PLANNING, ZONING, & BUILDING DEPARTMENT
PZ&B Staff Combination Memorandum: Architectural Commission and Town Council

SUBJECT: ARC-24-040 (ZON-24-046) 227 ANGLER AVE (COMBO)

MEETING: APRIL 24, 2024 ARCOM
MAY 15, 2024 TOWN COUNCIL

The applicant has submitted plans, entitled "Demolition of Existing Pergola, Replacement with Loggia, 224 Angler Ave" as prepared Kirchoff & Associates Architects, dated April 8, 2024.

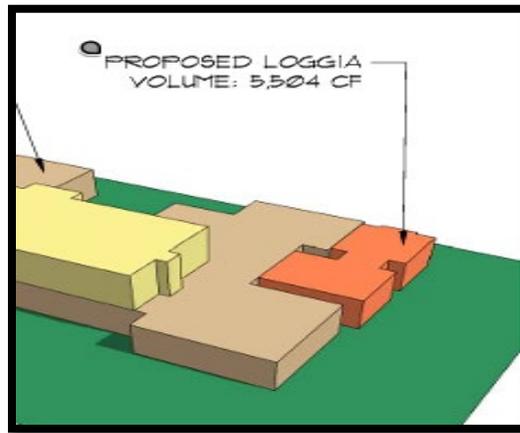
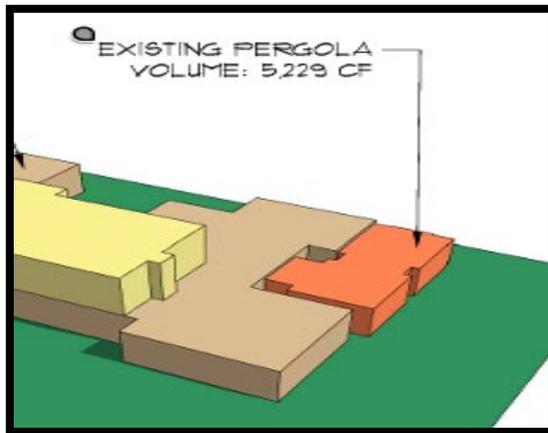
The application is for the construction of an enclosed loggia at the rear of an existing two-story residence. A preliminary review of the project indicates that the application, as proposed, is **inconsistent** with the Town zoning code and requires two variances (1) variance to exceed the allowable lot coverage and (2) variance to exceed the allowable cubic content ratio.

Staff notes that the progression from original construction will continue the deficiency in lot coverage and trigger relief from cubic content requirements. Lot coverage prior to the 167 SF awning replacement was 29.61% just under the 30% permitted. In 2020, with the addition of the 565 SF pergola over existing hardscape, the main house with the pergola covered 34% of the lot and the new loggia, although 15 SF less (33.26%) will still exceed allowable lot coverage. The zoning code permits a 5% credit to CCR for unenclosed loggias, pergolas, porches, terraces and covered patios and a 3% lot coverage exemption for awnings or trellises.

The applicant has made note within this application of rainwater/drainage issues with the current structure as well as concerns with their adjacent neighbor. Approval of the proposed loggia and variances would renew the parcels existing non-conformities.

At the March ARCOM meeting the commissioners expressed concern over the required variances to maintain the current deficiencies in lot coverage and CCR. The applicant has resubmitted with revisions including the reduction in column diameter, a redesign in the rafters to match the existing and a metal roof in lieu of the previously proposed wood however the footprint remains the same.
